ECE/TRANS/WP.29/GRE/2008/42  
11 July 2008

REGULATION No. 45  
(Headlamp cleaners)

Proposal for draft Supplement 6 to the 01 series of amendments to Regulation No. 45

"Diagram of Measuring Points on a Screen

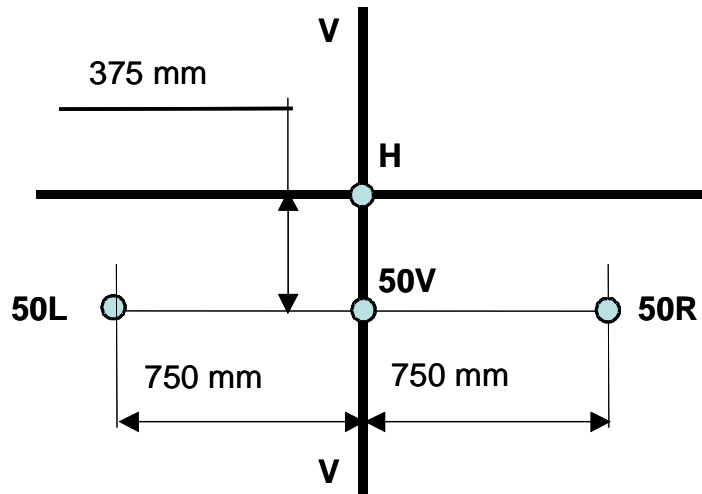
Paragraph 7.1., replace the existing diagram with the following:
